MANDATORY SERVICE BULLETIN

NO. MSB-40-064

This Service Bulletin prescribes the replacement of the 'alternator circuit breaker to main bus jumper wire' and the 'battery circuit breaker to essential bus jumper wire', P/N DA4-3144-60-03.

WI-MSB-40-064

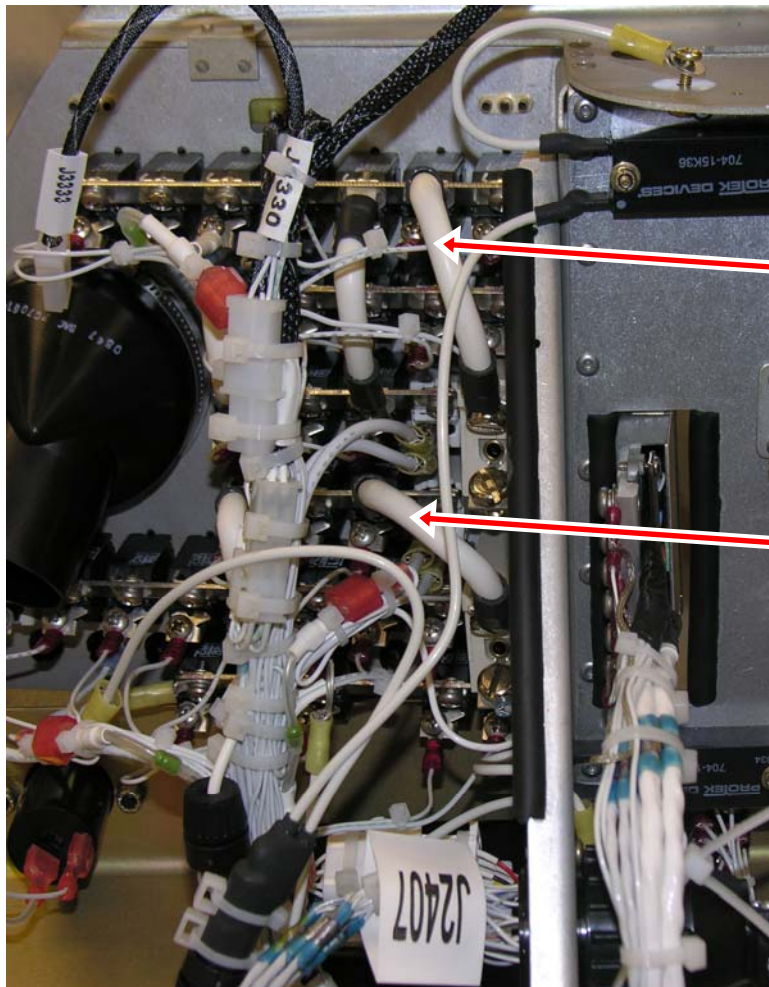
- 5 Replace the 'alternator circuit breaker to main bus jumper wire' and the 'battery circuit breaker to essential bus jumper wire', P/N DA4-3144-60-03, by new ones as indicated in the picture.
